Austin Transportation Department

June 15, 2016
To Stakeholder, Property Owner, or Resident:

This is an updated notification containing new information related to this project. Local stakeholder feedback was used to re-evaluate the proposed project, resulting in a change to traffic circulation. Discussions with Austin Independent School District (AISD) and stakeholders at the second open house led to a design change to keep Homedale Drive open to two-way traffic. The updated map below shows the change to Homedale Drive.

Figure 1 – Typical Cross Sections for Barton Hills Drive

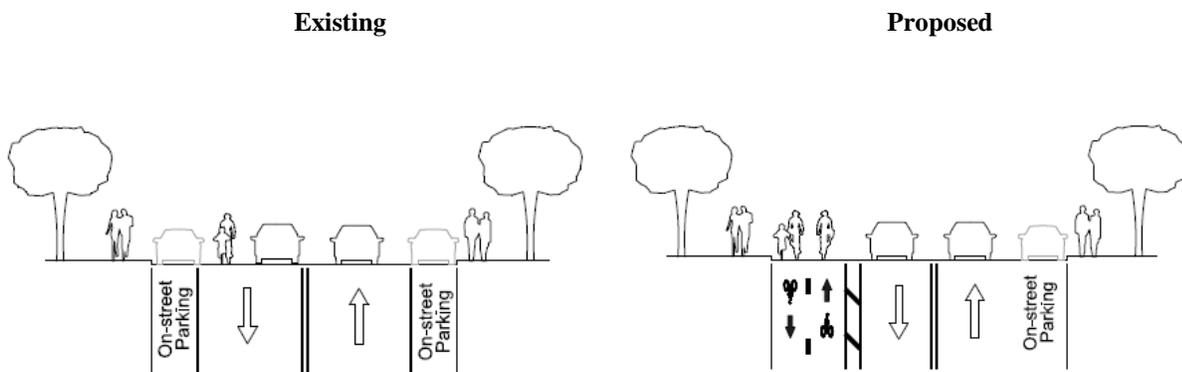
Typical proposed striping along Barton Hills Drive will have a two-way protected bikeway on the west side of the street and a parking lane on the east side of the street as shown in Figure 1. Special design consideration will be given to improved pedestrian crossings in response to numerous requests from citizens.

Figure 2 – Barton Hills Drive Project Area

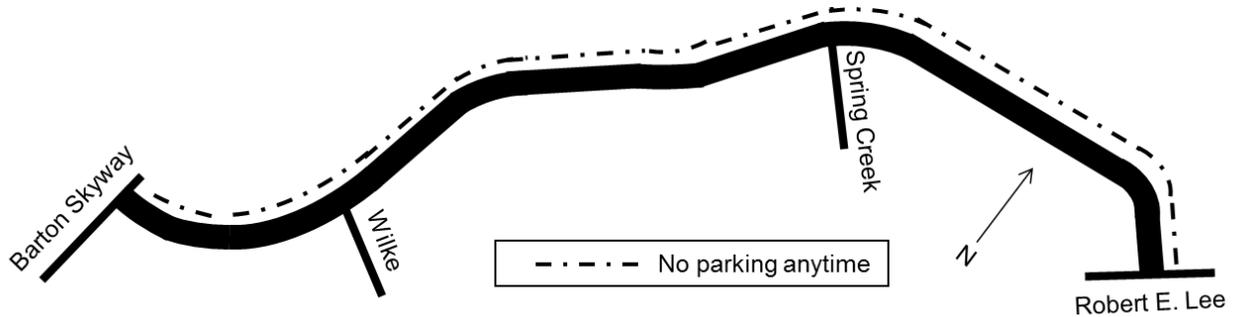
In order to add bicycle facilities on Barton Hills Drive, on-street motor vehicle parking will be prohibited at certain locations as listed below and in Figure 2. To relieve congestion on Barton Hills Drive during school pick-up and drop-off times, a westbound right turn lane will be added to facilitate entry into the elementary driveway. **Homedale Drive will remain open to two-way traffic** as listed below and in Figure 3. In addition, in

- **Barton Hills Drive** (from Robert E. Lee to Barton Skyway) – prohibit parking on the west side of the street.

Figure 3 – Homedale Drive Project Area

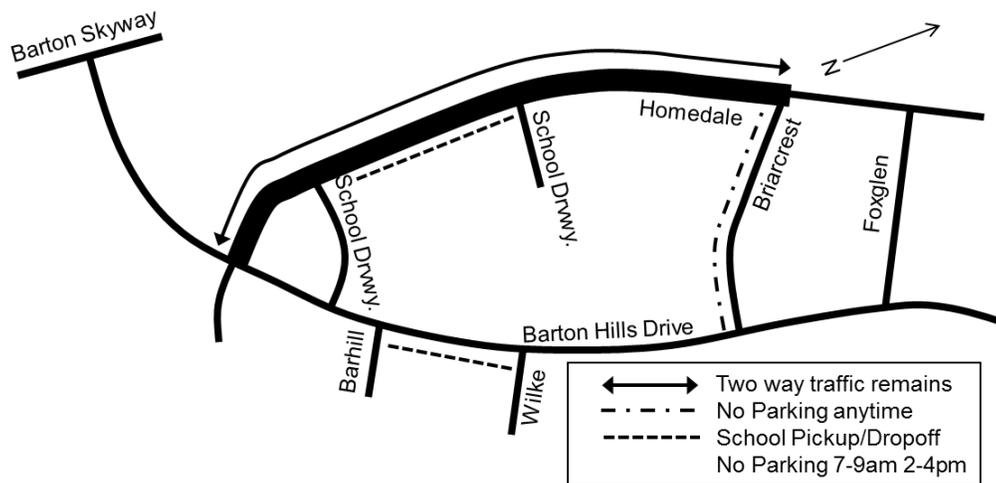
- **Homedale Drive** (from Briarcrest Drive to Barton Hills Drive) and **Briarcrest Drive**
